From: Hayden Ausland
Sent: Thursday, December 10, 2020 10:58 AM
To: 'grluci@gmail.com'; Kim McMillan
Cc: 'JWLuci@gmail.com'; Tabitha Boschetti; Steve Koper
Subject: RE: Stormwater Master Plan - Public Comment Period

From: G Lucini <grluci@gmail.com>
Sent: Monday, December 7, 2020 3:43 PM
To: Hayden Ausland <hausland@tualatin.gov>; Kim McMillan <kmcmillan@tualatin.gov>
Cc: John Lucini <JWLuci@gmail.com>
Subject: Re: Stormwater Master Plan - Public Comment Period

I understand the City is providing a Citizen Comment period ending December 15th. And I understand the proposed Master Plan will then be presented to the Planning Commission, and then to the City Council for adoption into the City's governing documents.

Figure 17. IMPLEMENTED Configuration - Velocities at Likely Flows 25-yr Design Storm Event
Upstream and Downstream Stations along the Lucini property approximate 150-foot Ditch

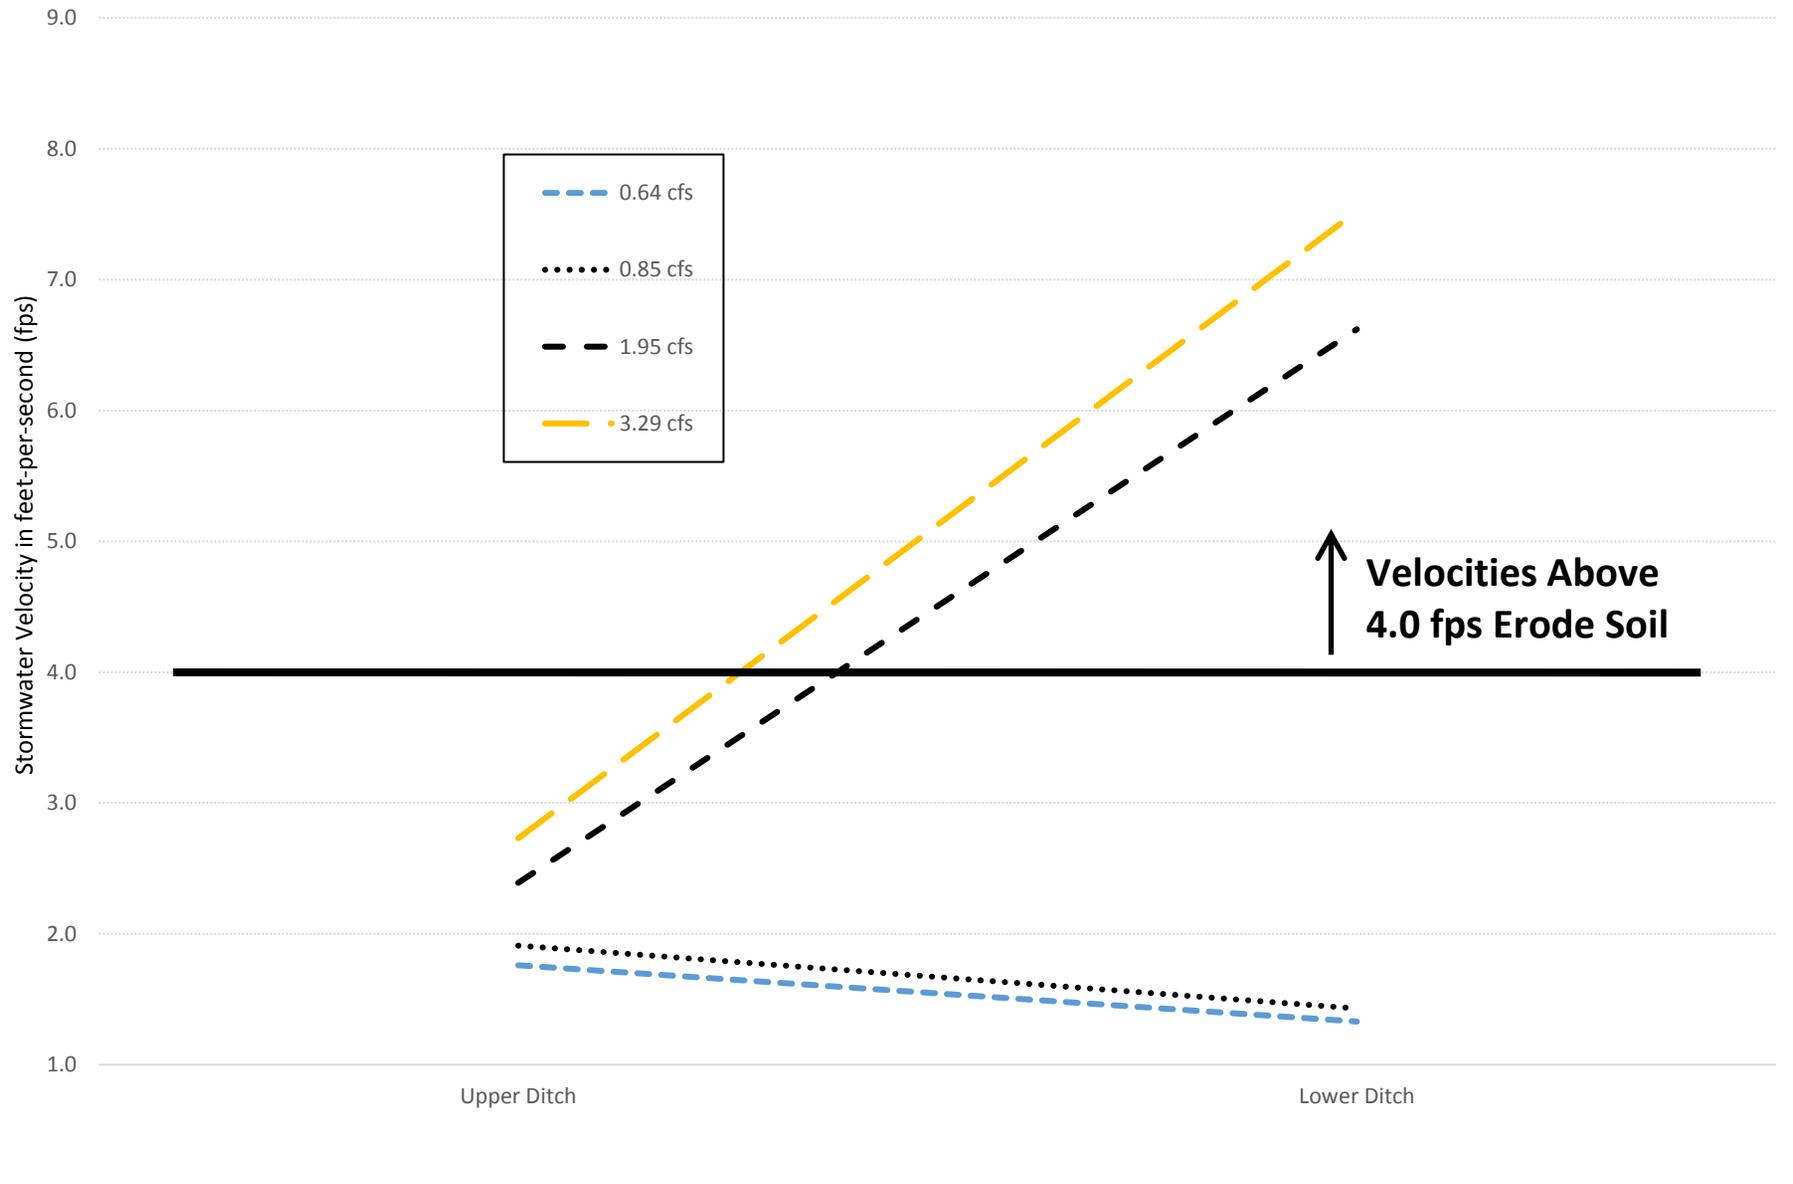
Stormflow velocities shown in Figure 17, for a range of land use conditions and the IMPLEMENTED subbasin configuration, demonstrate that values exceed velocities that cause erosion on the Lucini property for the ongoing land use and full build-out development conditions. These velocities exceed 4.0 feet-per-second (fps) and cannot be maintained. This harmful condition requires methods to reduce peak flows, including sediment and debris transport, passing through the County's culvert and onto the Lucini property. The physical conditions of excessive and increased streamflow on steep slopes existing on the Lucini property, and compared to IMPLEMENTED conditions, were not evaluated by the County in its Drainage Report.

Figure 17 for the IMPLEMENTED configuration illustrates velocities for the upstream and downstream stations along the Lucini property approximate 150-foot ditch. This figure shows that as stormflows increase from 0.85 cfs to 3.29 cfs, highly erosive storm velocities will occur into the future.
